From: FREGONESE, Victor <vxf@nei.org>
Sent: Wednesday, April 26, 2017 2:23 PM
To: Drake, Jason
Cc: Morton, Wendell; Rahn, David; GEIER, Stephen; REMER, Jason
Subject: [External_Sender] NEI Comments on Draft RIS and Draft Qual Assessment Guidance
Attachments: Draft_RIS_to_Clarify_RIS_2002-22_04-20-2017 Meeting Copy [NEI Comments 4-26].docx; Qualitative Assessment Guidance 04-20-2017 Public Meeting Copy [NEI Comments 4-26].docx

**NRC REGULATORY ISSUE SUMMARY 2017-XX
UPDATE TO THE STAFF ENDORSEMENT ON THE USE OF
EPRI/NEI JOINT TASK FORCE REPORT,
“GUIDELINE ON LICENSING DIGITAL UPGRADES: EPRI TR-102348,
REVISION 1, NEI 01-01: A REVISION OF EPRI TR-102348 TO
REFLECT CHANGES TO THE 10 CFR 50.59 RULE”
(REPORT PREVIOUSLY ENDORSED BY WITHIN RIS 2002-22)**

Draft – Qualitative Assessment Framework

Figure 1 - RIS Decision Tree Flowchart

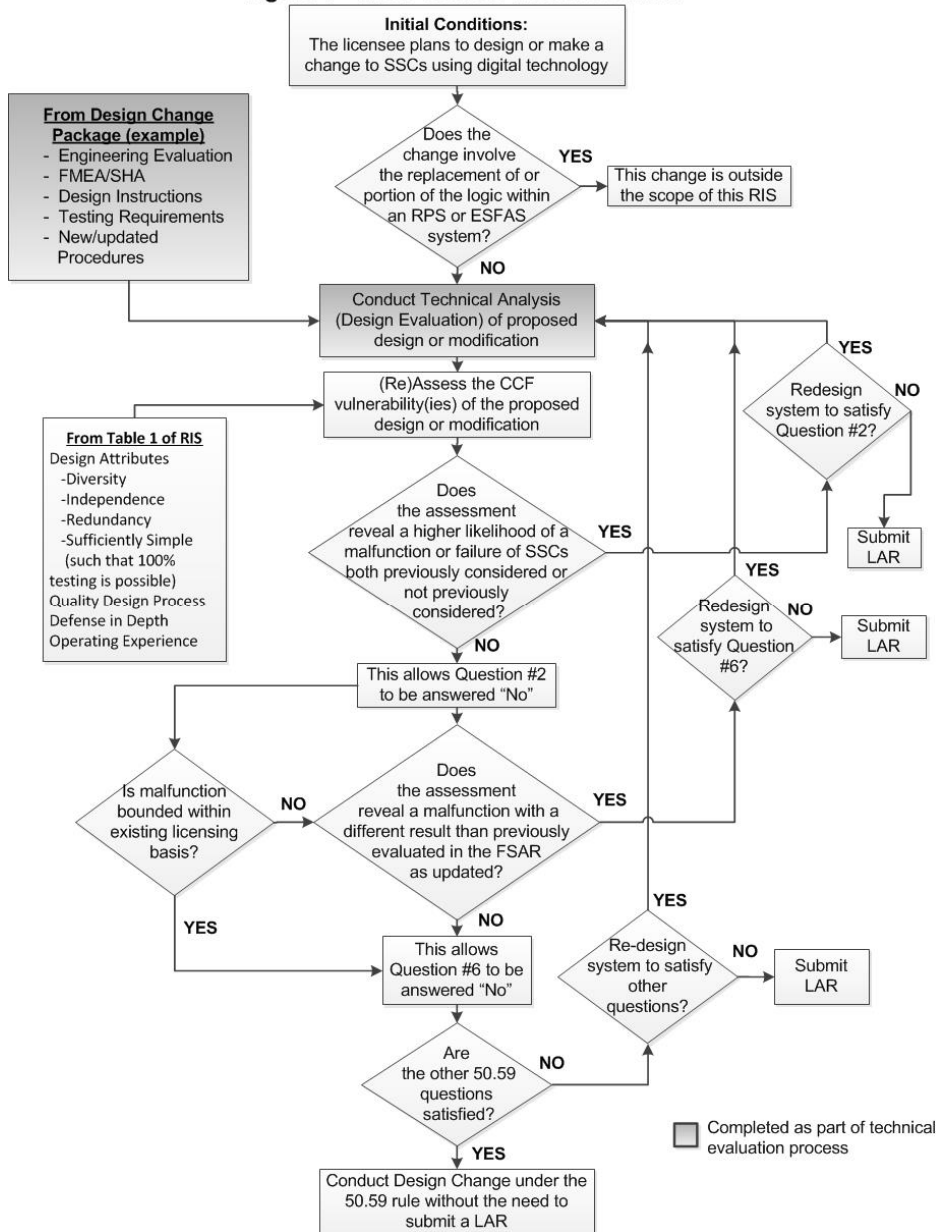
Commented [vxf26]: There is no box for 50.59 Question #6.

Commented [vxf27]: Many of the "rectangles" on the flow chart do not have a "yes" or "no". For instance, the box that contains "This allows Question #2 to be answered NO". Please clarify this in the flowchart.

Commented [vxf28]: Please refer to previous comment on the 100% testability in Table 1.

Commented [vxf29]: Please clarify what the purpose of the decision block that states: "Is malfunction bounded within the existing licensing basis?"
